Subject: Transmittal of Revision 1 to Service Bulletin
No. V2500-ENG-79-0073

V2500-ENG-79-0073

International Aero Engines SERVICE BULLETIN

ENGINE - OIL - INTRODUCTION OF OIL RESTRICTOR OF FBC OIL LINE
WITH REVISED THROAT SIZE

Modification of the oil restrictor
Figure 3

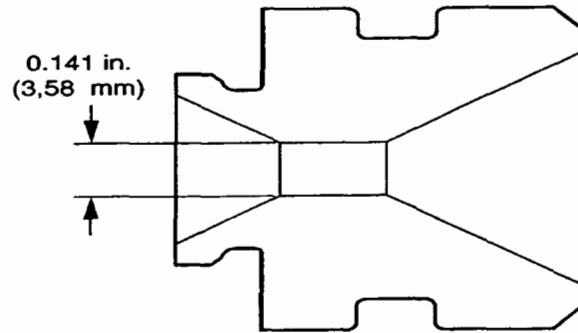
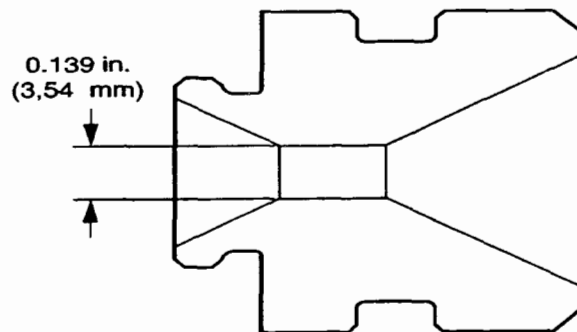
(a) The throat diameter of oil restrictor which is installed in the main oil distributor have changed from 0.141 inch (3,58 mm) to 0.139 inch (3,54 mm).

(b) The oil restrictor for A5 model is introduced for A1 model.

- (1) Remove the oil restrictor, (5A0261, 1 off) from the main oil distributor. For the correct procedures, refer to the Engine Manual (EM), Chapter/Section, 72-32-00, Disassembly-12).
- (2) Install the new oil restrictor, (5A1451, 1 off) into the main oil distributor. For the correct procedures, refer to the Engine Manual (EM), Chapter/Section, 72-32-00, Assembly-04).
